**HUGHES
SERVICE INFORMATION
NOTICE**

NOTICE NO. N-139

SUBJECT: MODIFICATION - LEFT-HAND FRONT ENGINE COOLING SHROUD PANEL ASSEMBLY, PN 269A8508-15 OR -25; AND ENGINE MOUNTING BOLT INSTALLATION

MODELS AFFECTED: Model 269C Helicopter Serial No. 0001 thru 0408
Model 269B Helicopter Serial No. 0124 and subsequent equipped with Subject Panel Assembly

Figure 1. Modification - 269A8508-15/-25 engine coding shroud panel assembly

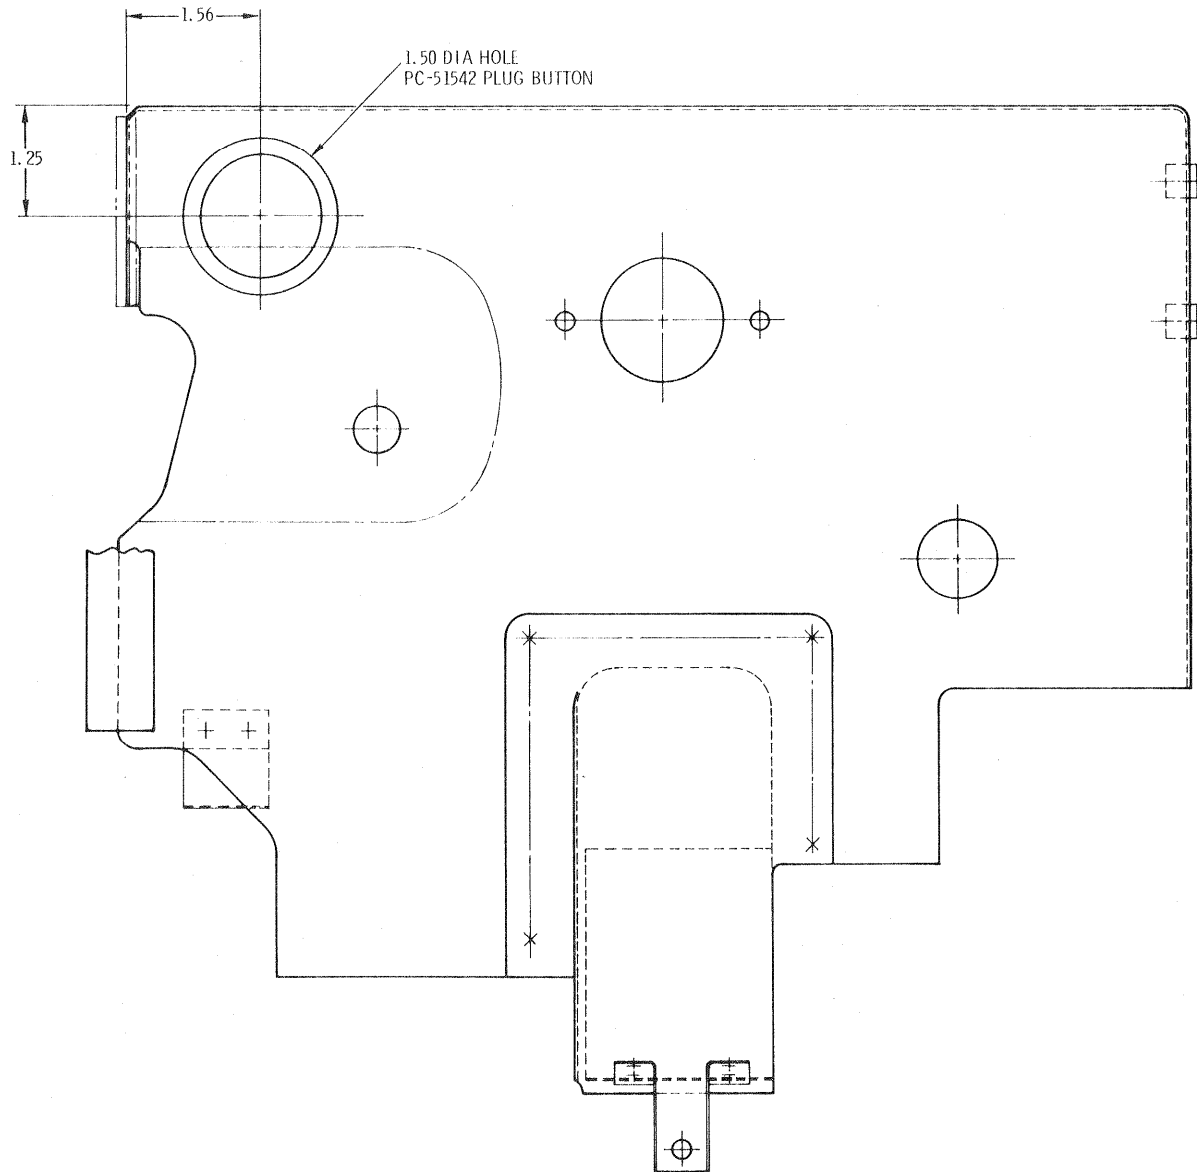
- a. Remove left-hand front engine cooling shroud panel, per referenced Basic HMI and applicable HMI Configuration Supplement.
- b. Using flycutter or equivalent tool, cut 1.50-inch diameter hole in panel assembly at dimensions shown in Figure 1.
- c. Reverse direction of existing NAS1308-55D engine mounting bolt at forward left-hand side of engine. Use existing washers and spacers for reinstalling bolt.
- d. Reinstall panel assembly.
- e. Install PN PC-51542 plug button in new access hole.
- f. Record modification per this Service Information Notice in Components Record of Helicopter Log Book.
